Reference: Hanford Waste Vitrification Plant
DOE Contract DE-AC06-86RL10838
Fluor Contract 8457

US DEPARTMENT OF ENERGY
HANFORD WASTE VITRIFICATION PLANT

DESIGN CHANGE NOTICE

DCN - 0060	REV 1	PAGE 1 OF 12
DCN TITLE: TBD/Hold on Canister Storage Tube Length and Tube Base Assembly		DATE INITIATED: 8-27-93
		PACKAGE NO.: E350

1 STANDARD TUBE ASSEMBLY

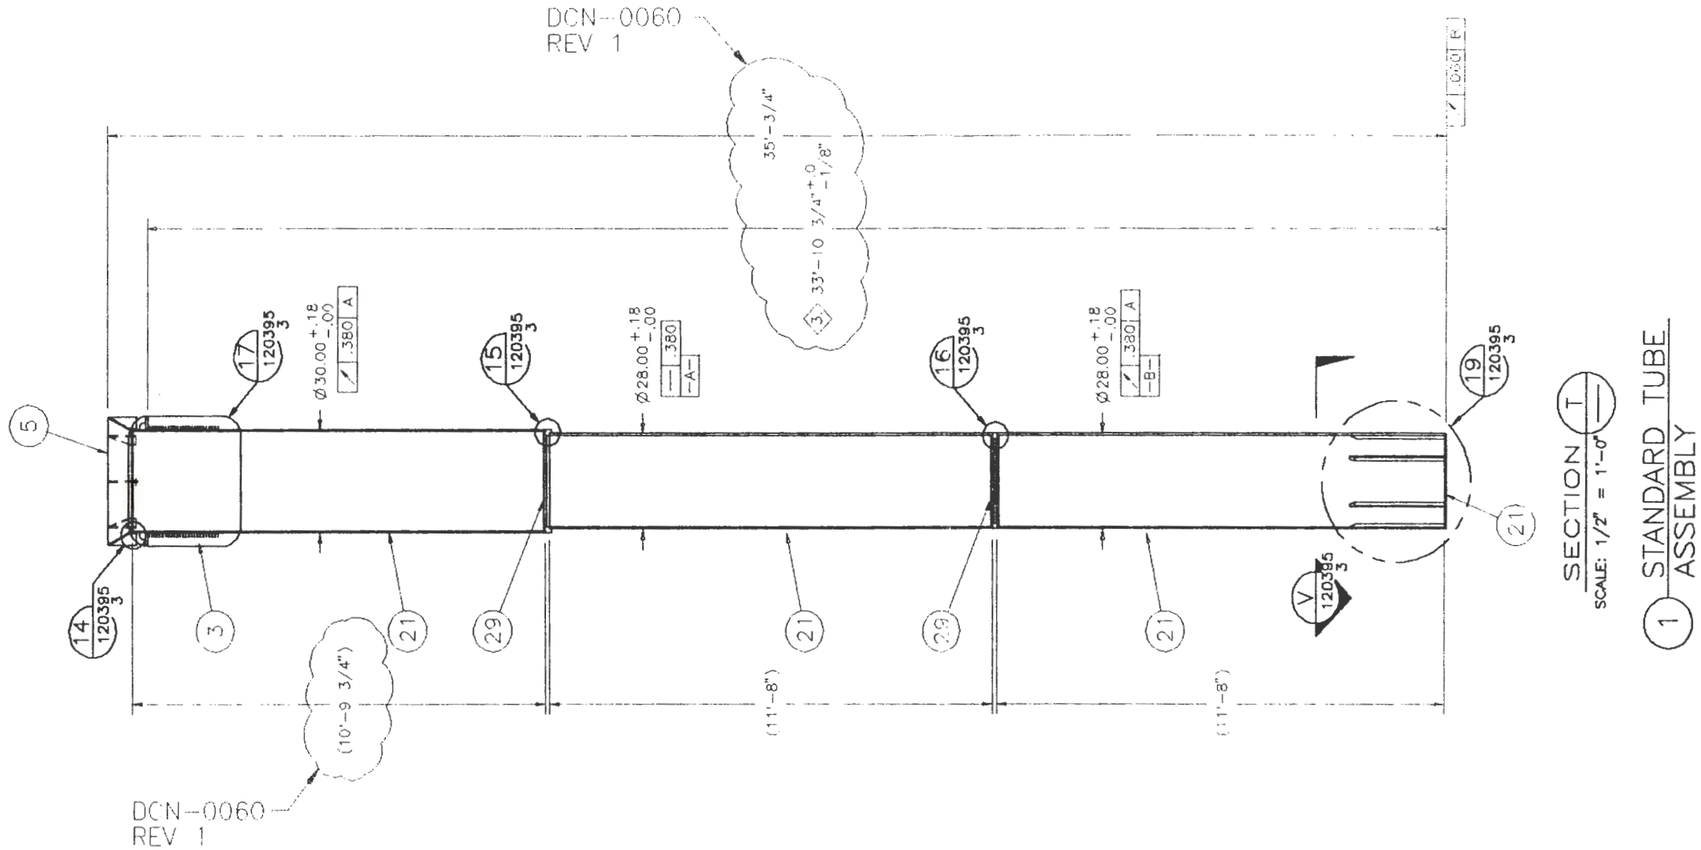
FLUOR DANIEL	U.S. DEPARTMENT OF ENERGY HANFORD WASTE VITRIFICATION PLANT	DESIGN CHANGE NOTICE
DESCRIPTION OF CHANGE: MODIFY STANDARD/OVERPACK CANISTER STORAGE TUBES		BASE DOC. NO. H-2-120395 SHT/PG. 1 REV. 1 CR NO. N/A DISCIPLINE: MECHANICAL
PREPARED BY:	DATE: 9-14-93	DCN-0060 / REV. 1 / PAGE 3A
DISCIPLINE ENGINEER: R. Hulskamp	DATE: 9-16-93

2 OVERPACK TUBE ASSEMBLY

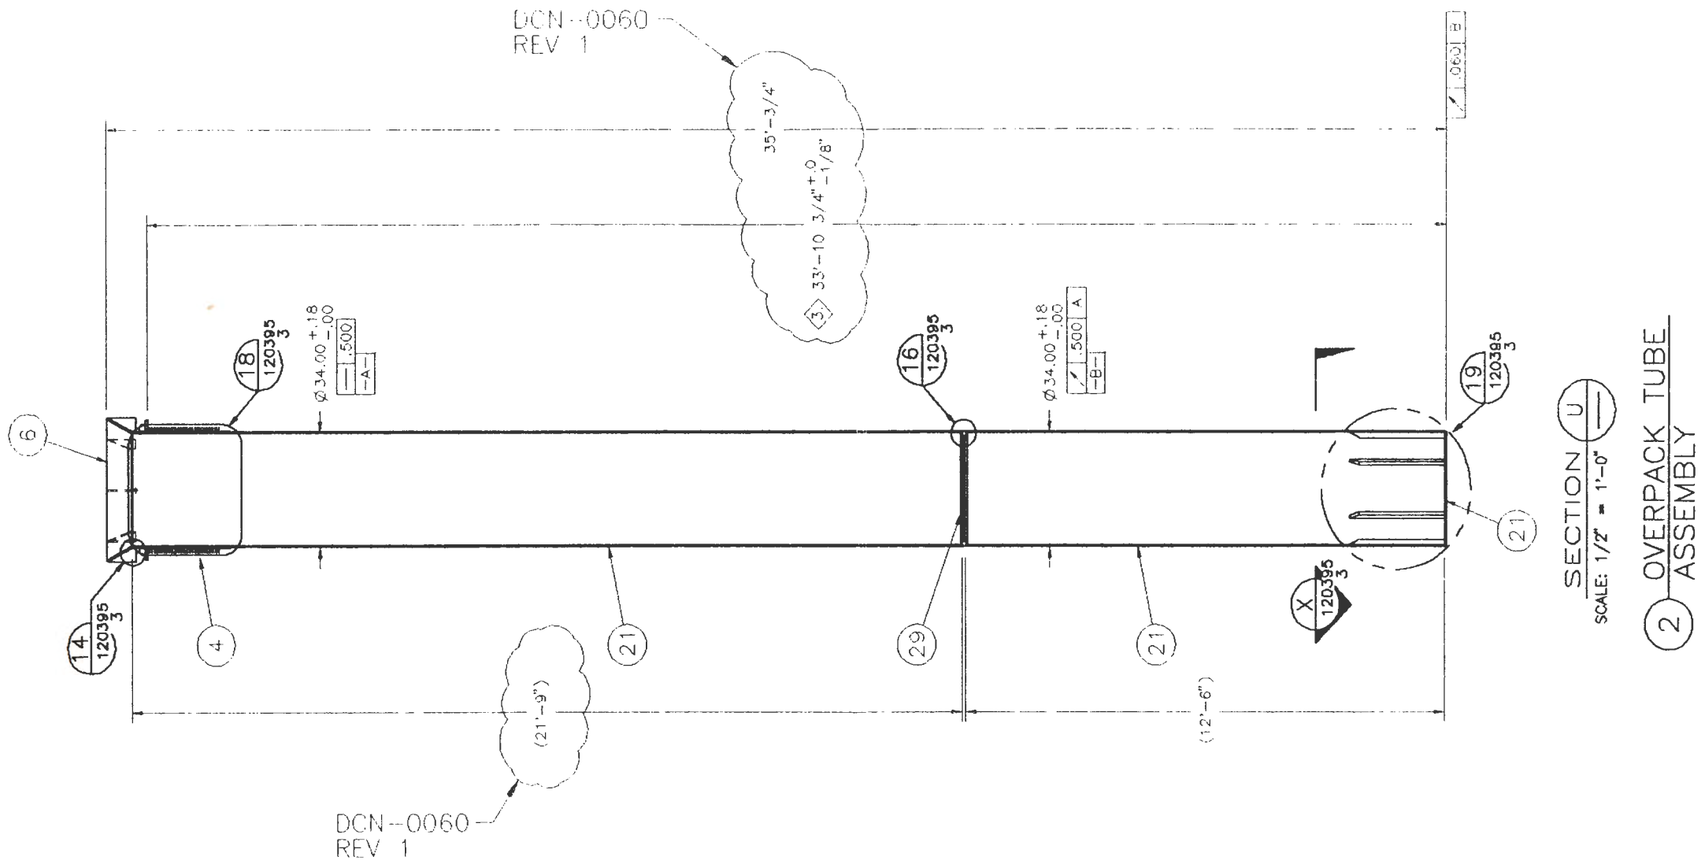
FLUOR DANIEL	U.S. DEPARTMENT OF ENERGY HANFORD WASTE VITRIFICATION PLANT	DESIGN CHANGE NOTICE
DESCRIPTION OF CHANGE: MODIFY STANDARD/OVERPACK CANISTER STORAGE TUBES		BASE DOC. NO. H-2-120395 SHT/PG. 1 REV. 1 CR NO. N/A DISCIPLINE: MECHANICAL
PREPARED BY:	DATE: 9-14-93	DCN-0060 / REV. 1 / PAGE 3B
DISCIPLINE ENGINEER: R. Hulskamp	DATE: 9-16-93

1 STANDARD TUBE BASE ASSEMBLY

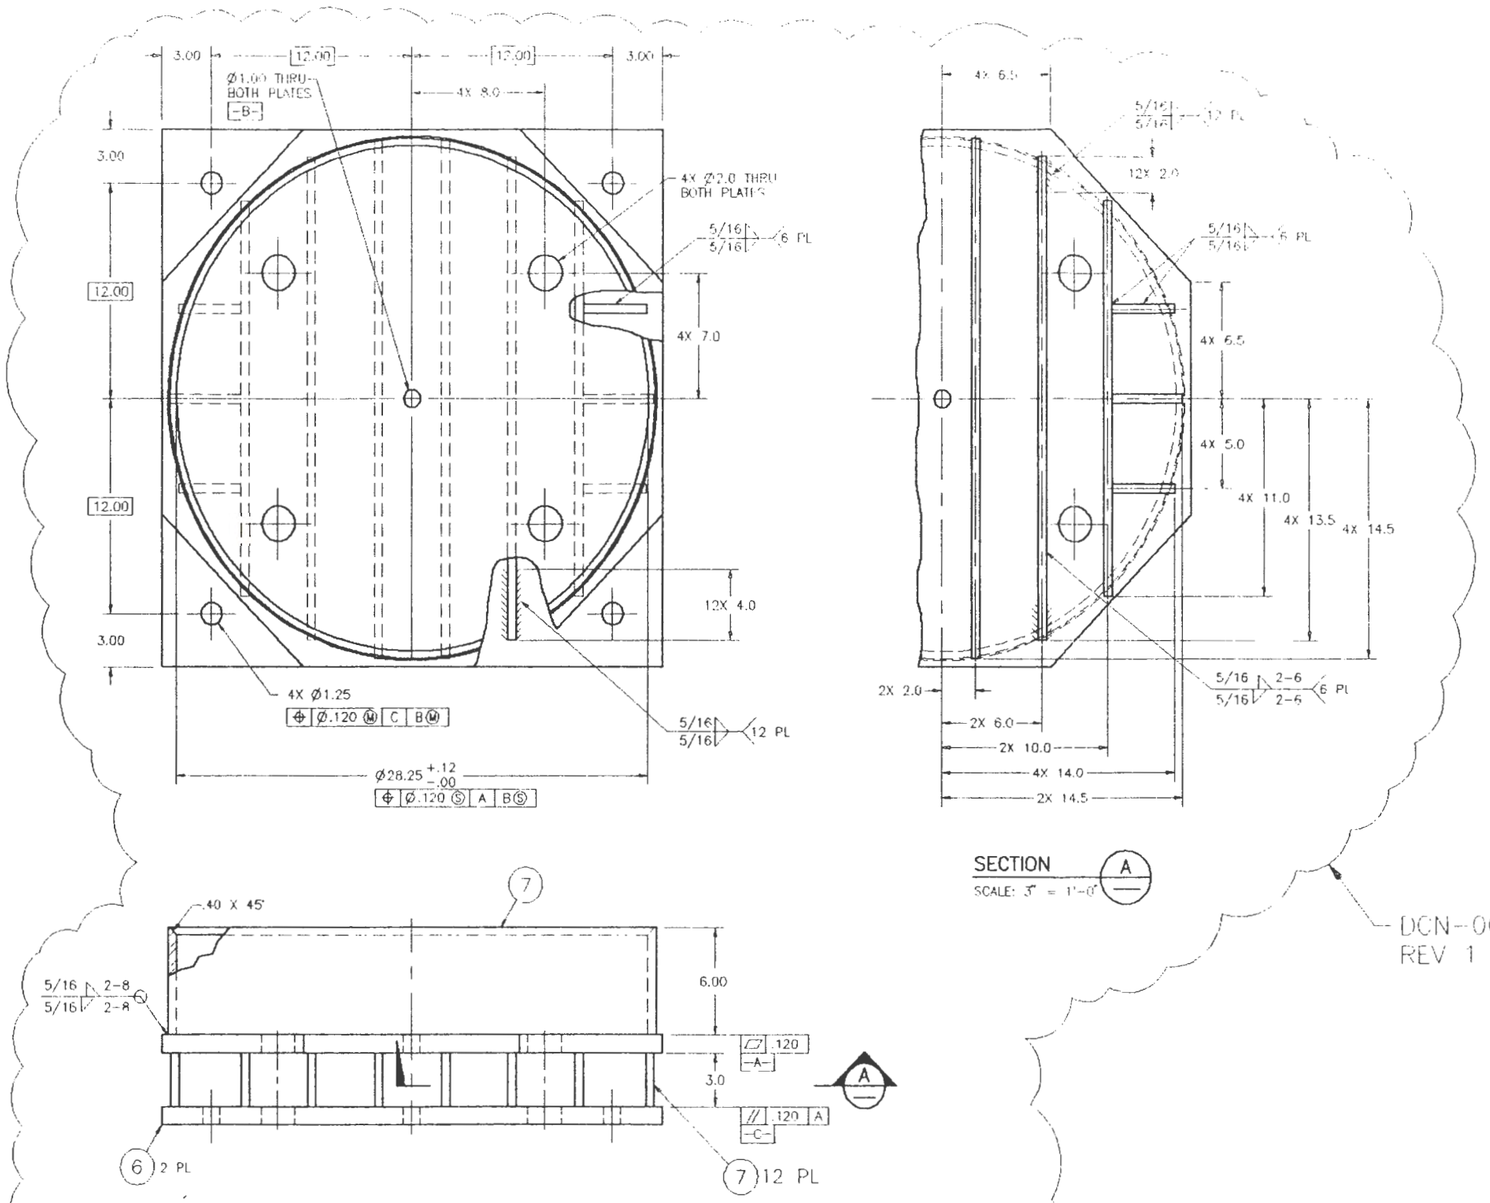
MODIFY STANDARD/OVERPACK TUBE BASE ASSEMBLY

BASE DOC. NO. H-2-120396
SHT/PG. 1 REV. 1
CR NO. N/A
DISCIPLINE: MECHANICAL

2 OVERPACK TUBE BASE ASSEMBLY

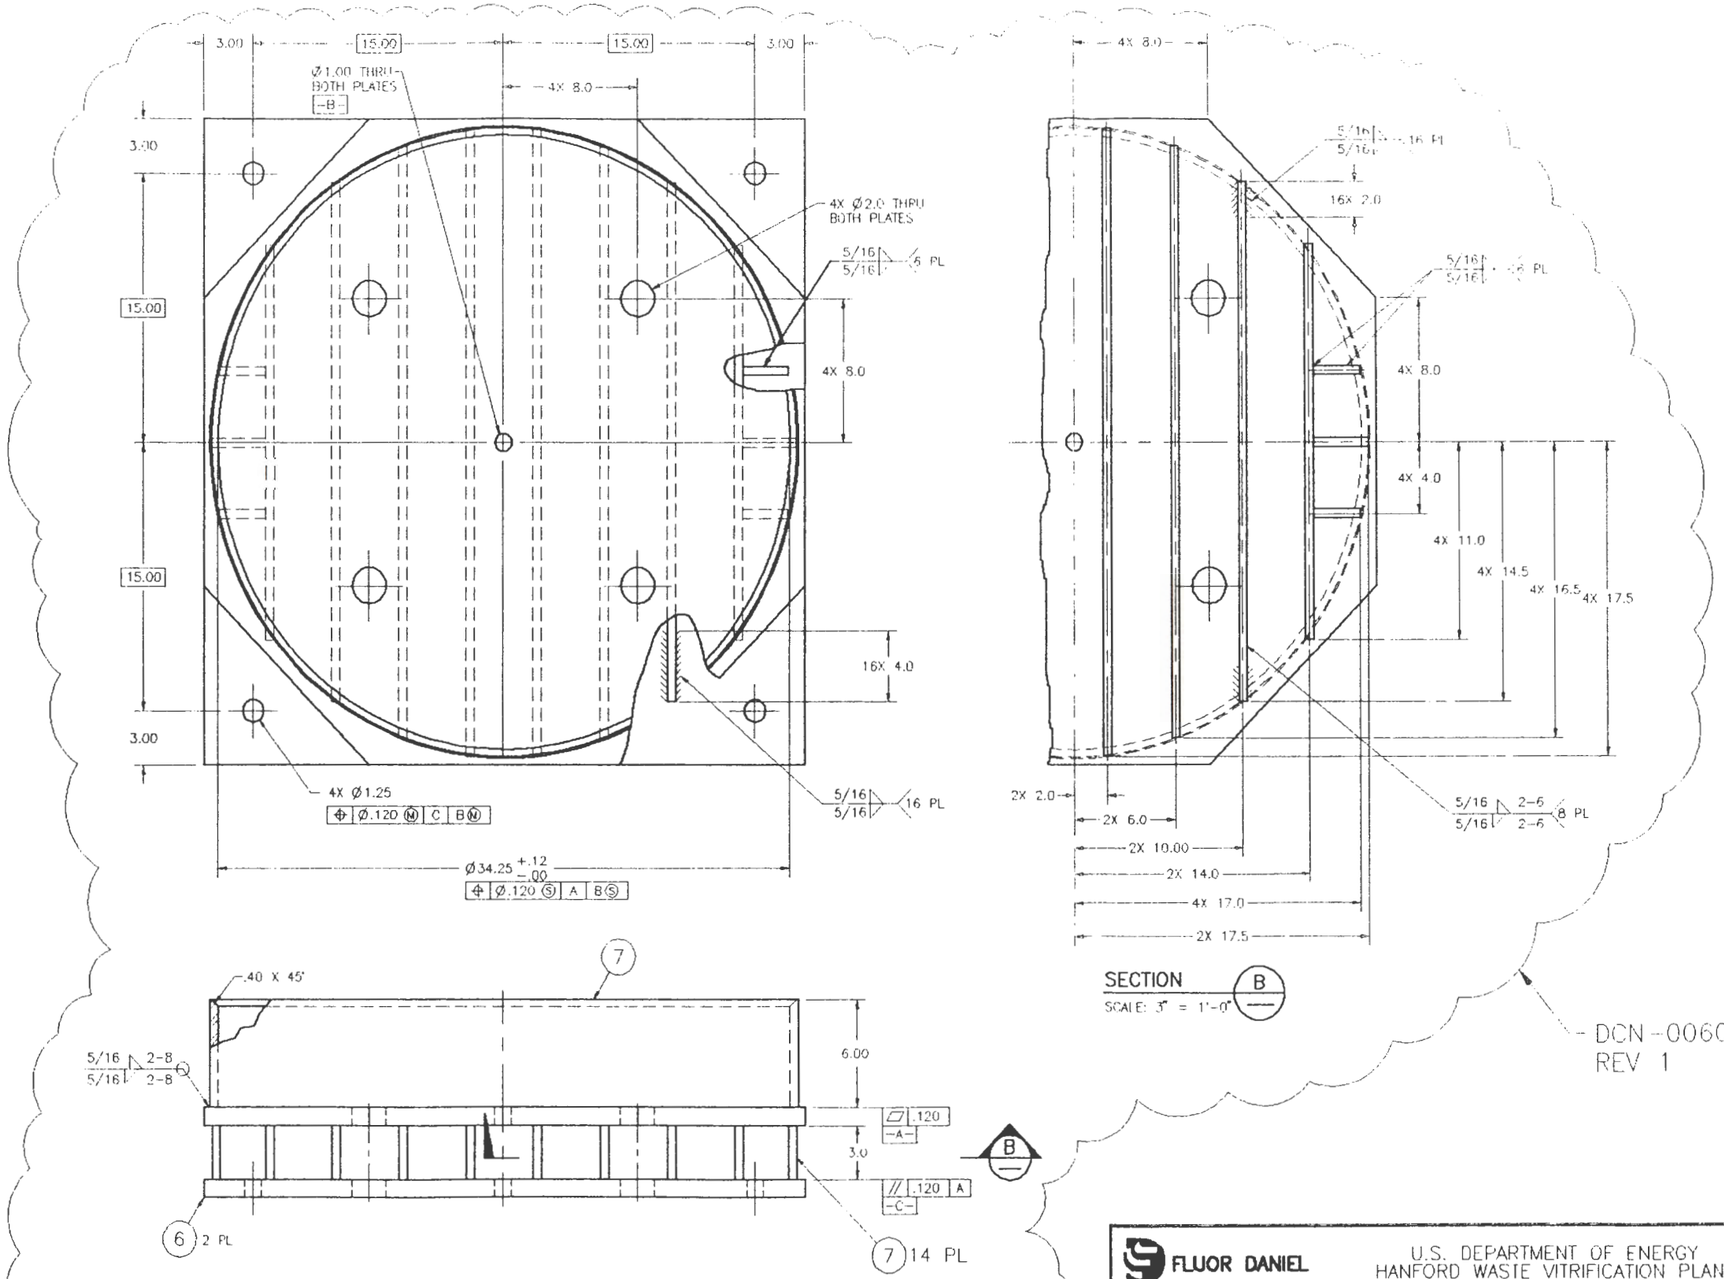
FLUOR DANIEL	U.S. DEPARTMENT OF ENERGY HANFORD WASTE VITRIFICATION PLANT	DESIGN CHANGE NOTICE
DESCRIPTION OF CHANGE: MODIFY STANDARD/OVERPACK TUBE BASE ASSEMBLY		BASE DOC. NO. H-2-120396 SHT/PG. 1 REV. 1 CR NO. N/A DISCIPLINE: MECHANICAL
PREPARED BY:	DATE: 9-14-93	DCN-0060 REV. 1 PAGE 4B
DISCIPLINE ENGINEER: R. Kulskamp	DATE: 9-16-93

1 STANDARD CANISTER STORAGE TUBE ASSEMBLY (660 REQD)

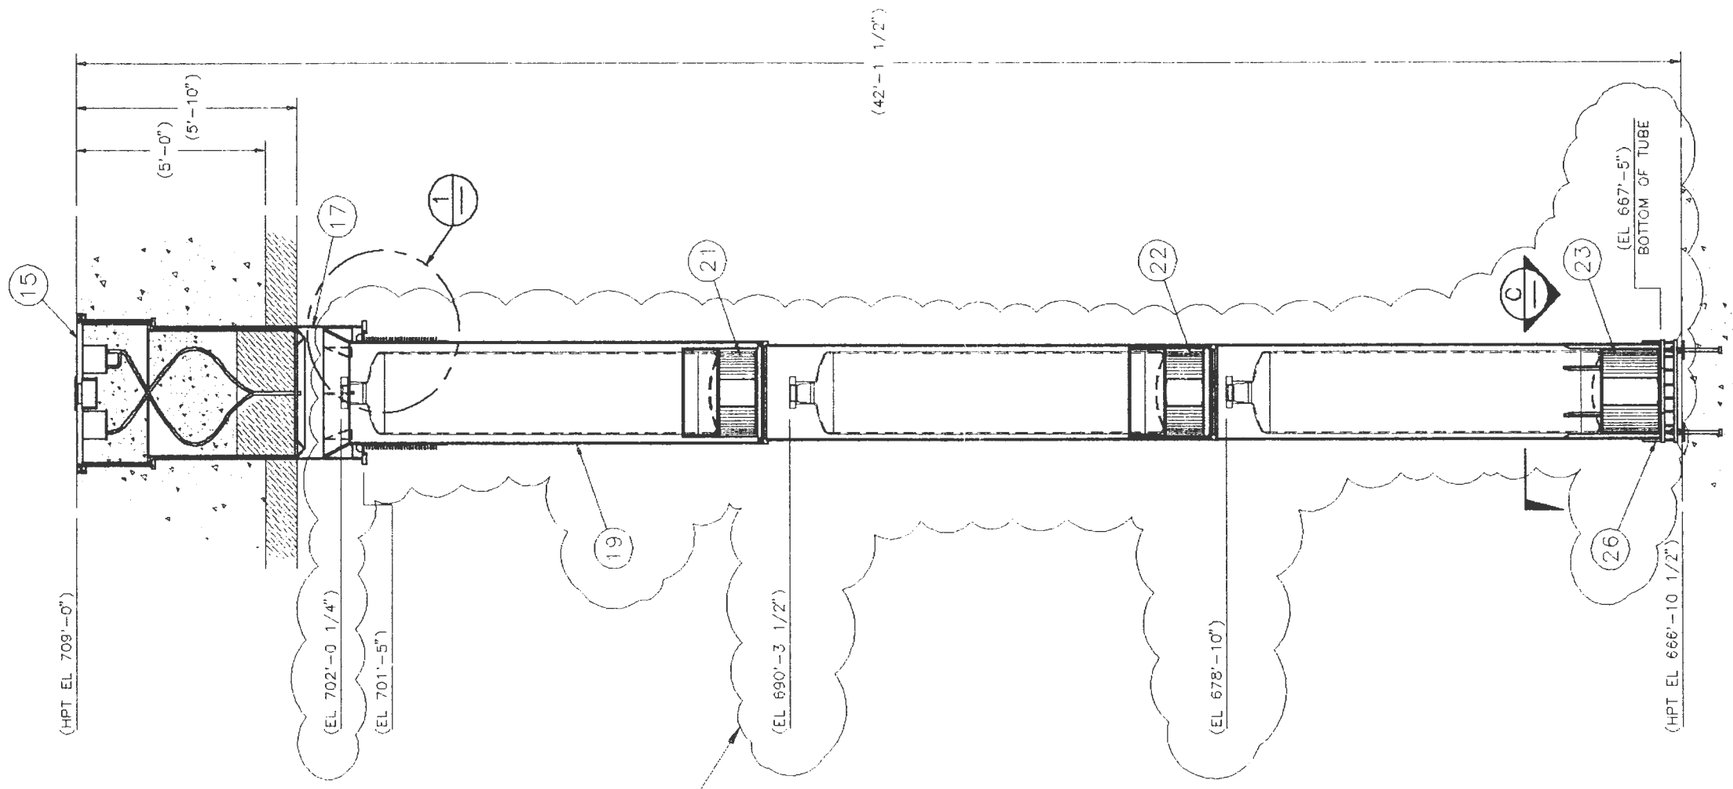
FLUOR DANIEL	U.S. DEPARTMENT OF ENERGY HANFORD WASTE VITRIFICATION PLANT	DESIGN CHANGE NOTICE
DESCRIPTION OF CHANGE: CHANGE STANDARD CANISTER STORAGE TUBE ASSEMBLY AND TUBE BASE ASSEMBLY		BASE DOC. NO. H-2-120397 SHT/PG. 1 REV. 1 CR NO. N/A DISCIPLINE: MECHANICAL
PREPARED BY: John H. Sack	DATE: 9-14-93	DCN-0060 REV. 1 PAGE 5
DISCIPLINE ENGINEER: R. Hulskamp	DATE: 9-16-93

2 OVERPACK CANISTER STORAGE TUBE ASSEMBLY (17 REQD)

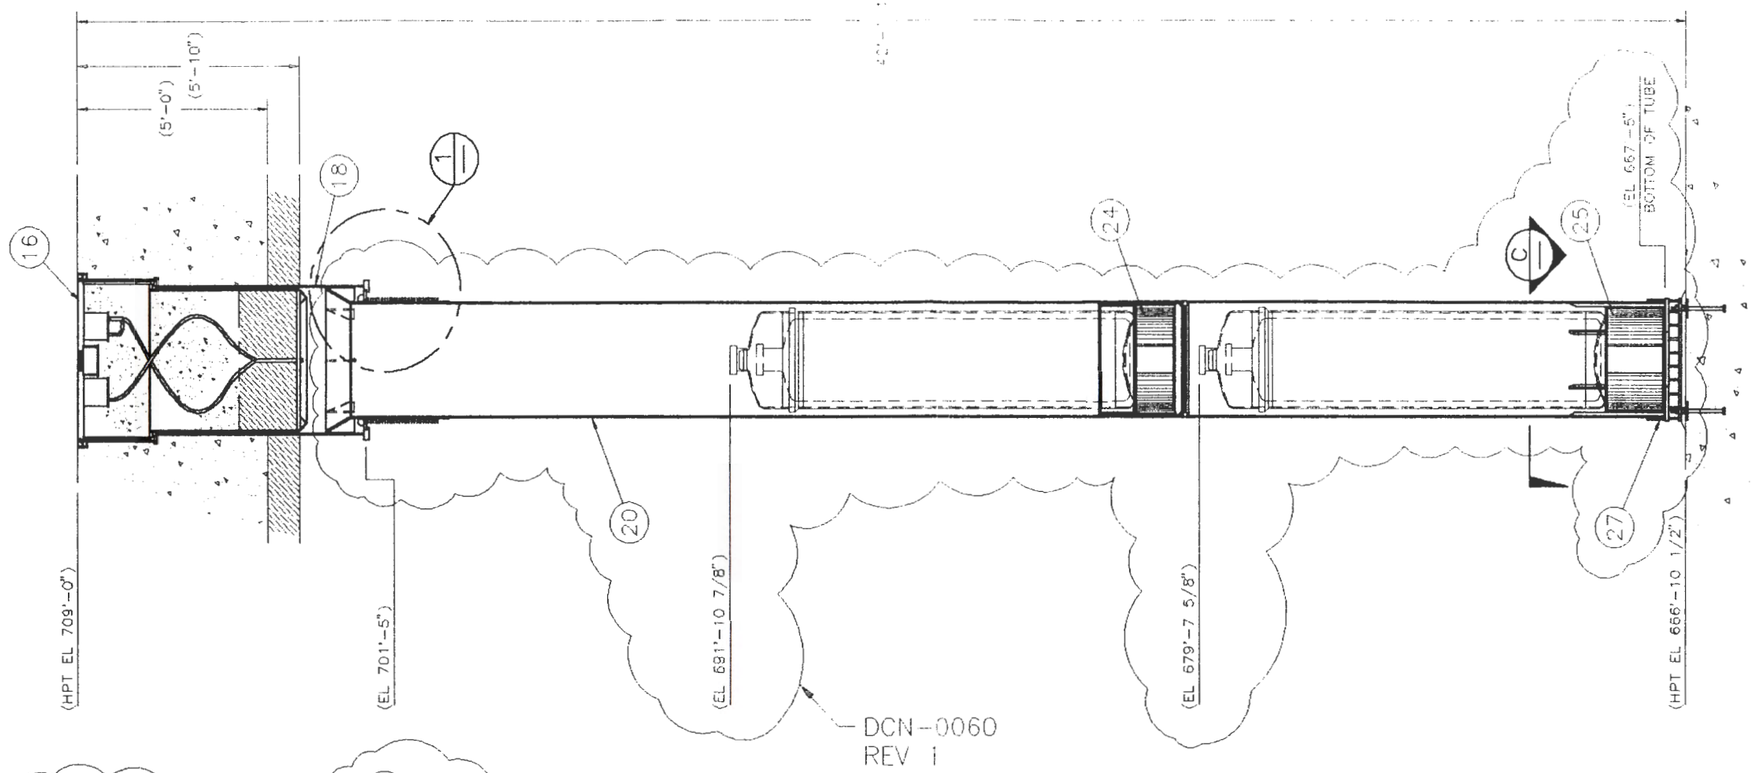
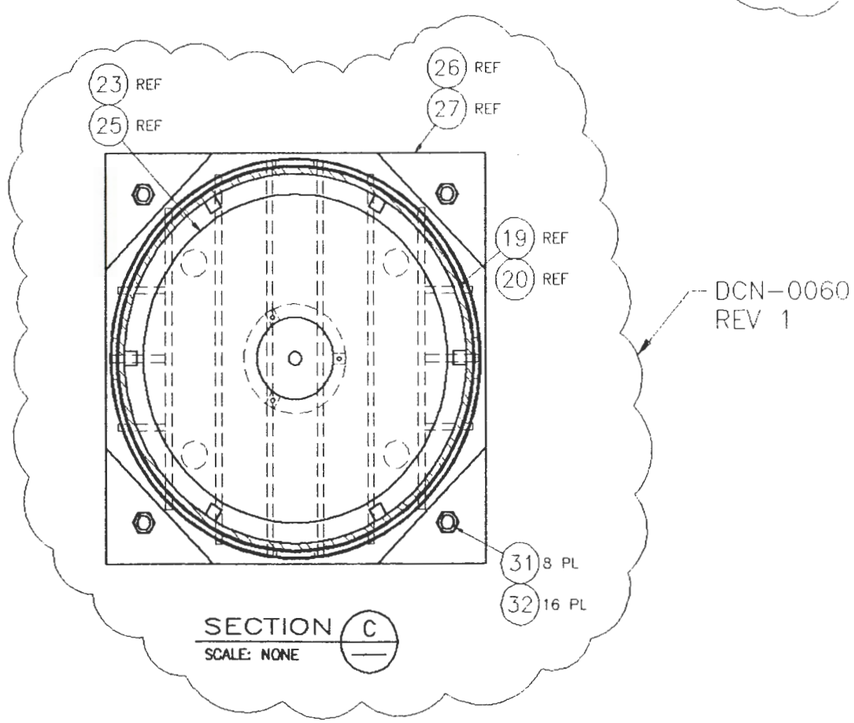
FLUOR DANIEL	U.S. DEPARTMENT OF ENERGY HANFORD WASTE VITRIFICATION PLANT	DESIGN CHANGE NOTICE
DESCRIPTION OF CHANGE: CHANGE OVERPACK CANISTER STORAGE TUBE ASSEMBLY AND TUBE BASE ASSEMBLY		BASE DOC. NO. H-2-120397 SHT/PG. 1 REV. 1 CR NO. N/A DISCIPLINE: MECHANICAL
PREPARED BY:	DATE: 9-14-93	DCN-0060 REV. 1 PAGE 6
DISCIPLINE ENGINEER: R. Hulskamp	DATE: 9-16-93
